# EAGLE MOUNTAIN
# CITY COUNCIL MEETING

| **TITLE:** | DISCUSSION - Mountainland Supply (Wolverine Ventures) Site Plan |

Attachments to this staff report include the current second review redlines and the third review resubmittal. The third set of plans is currently under review and is not closed out at this time so redline comments will not be present.

## SITE PLAN
## EAGLE MOUNTAIN, UTAH
## FINAL PLAN SET
## FEBRUARY 2024

SPRINKLER PLAN (15" x 21") 1" = 40'-0" (30" x 42") 1" = 20'-0"

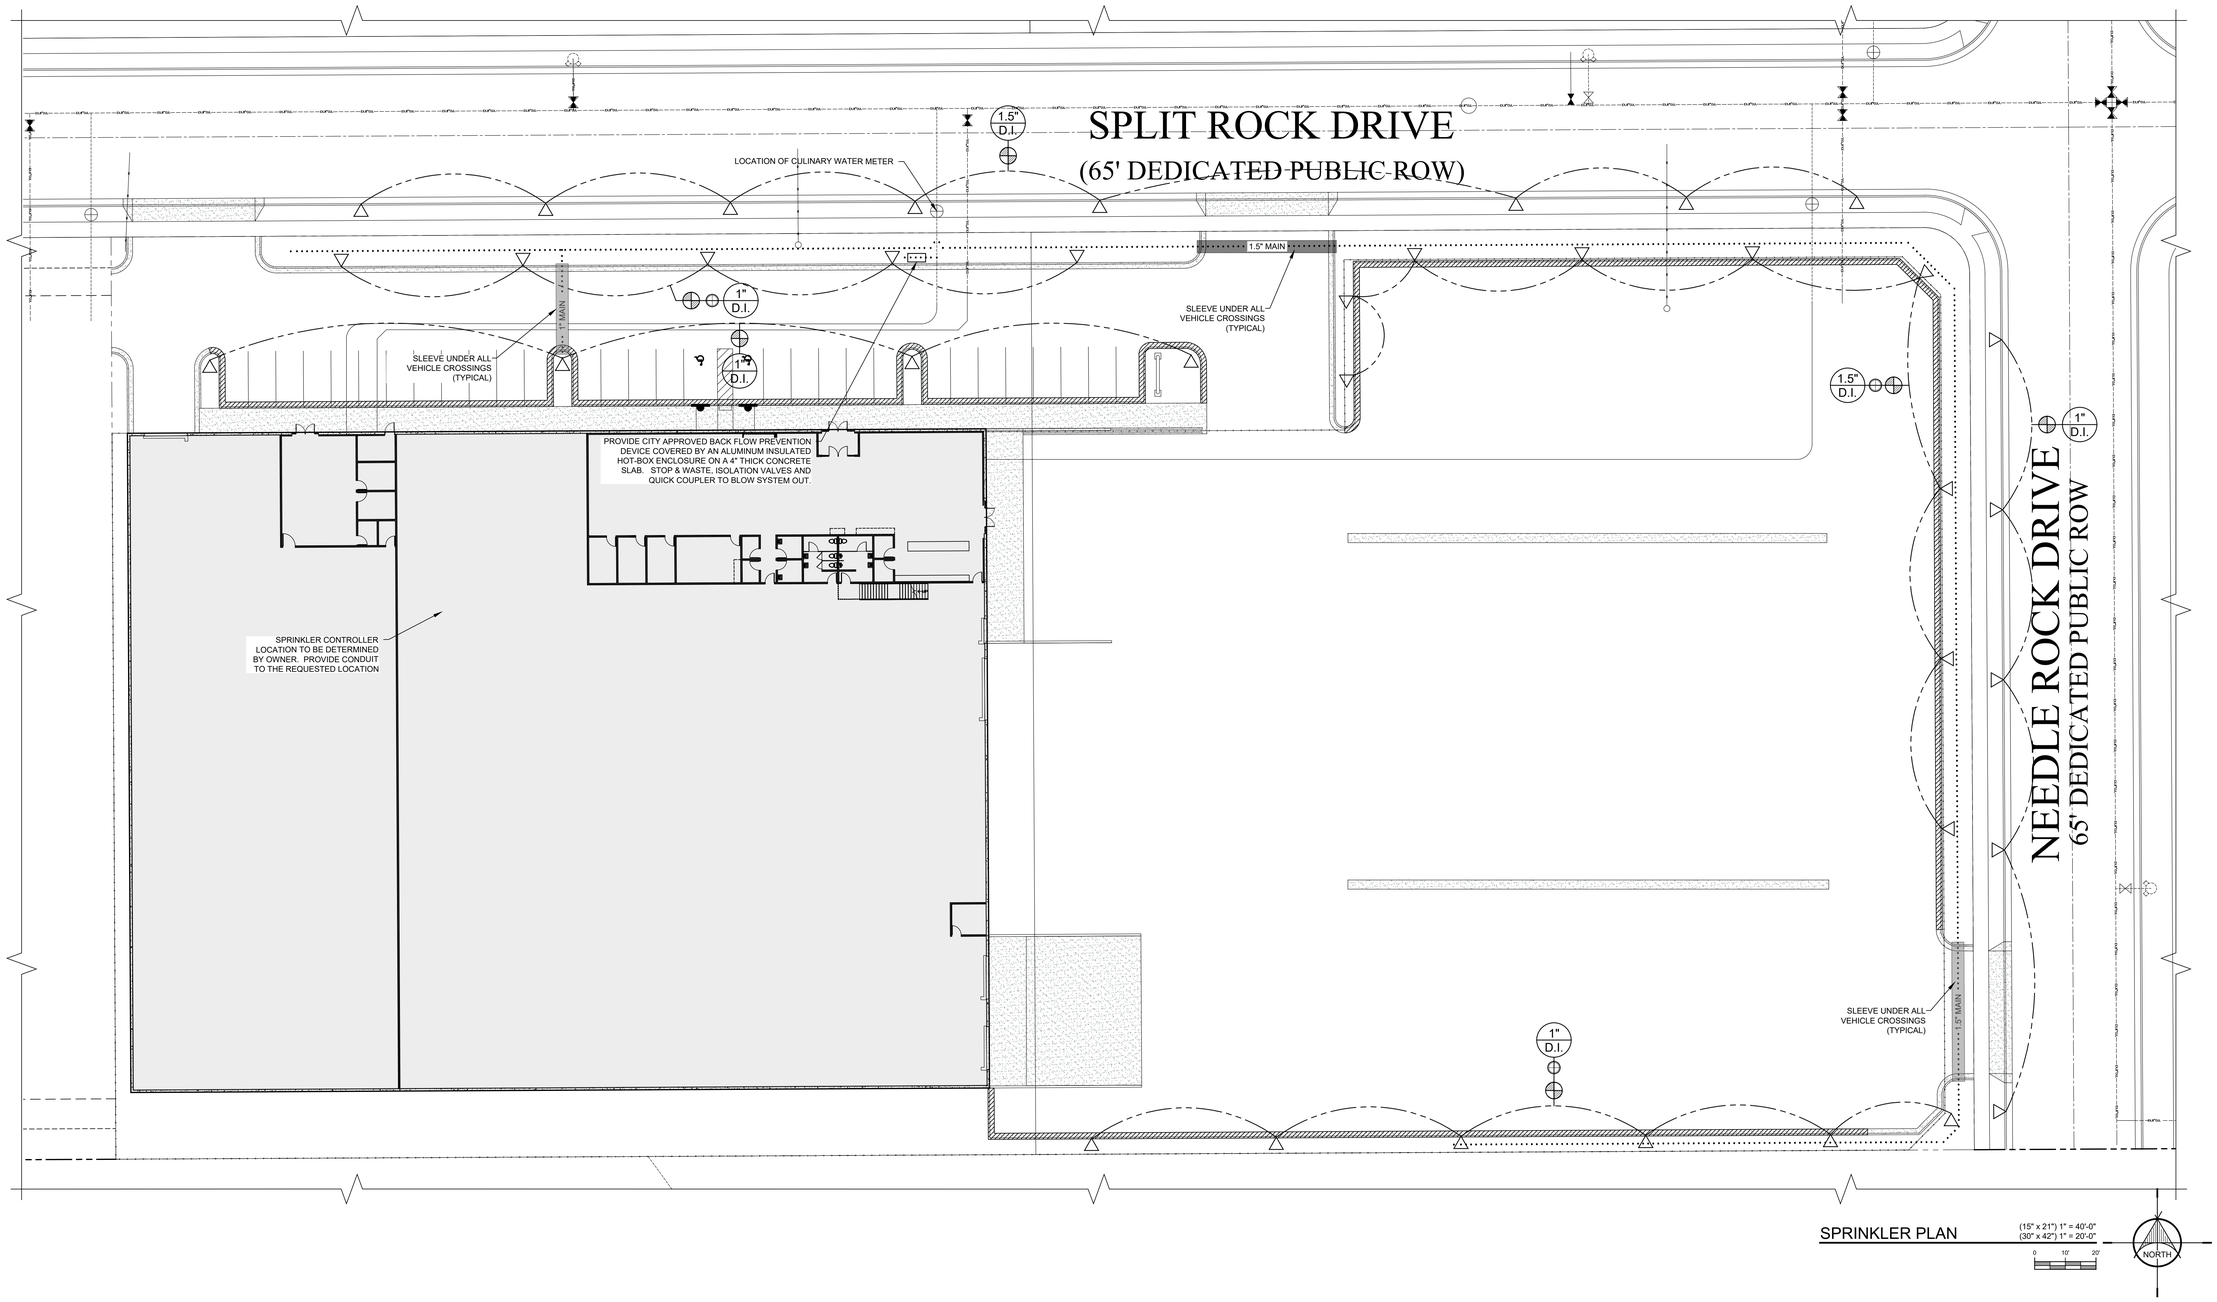
Lighting? Previous comment. No return of lighting from architect. Parking lot lighting (site) and building lighting (architecture) are typically provided together. Review EMMC 17.56. Downlight, full cutoff and night sky compliant. 100,000 lumens or less per net acre. Submit cut sheets and lumen calcs.
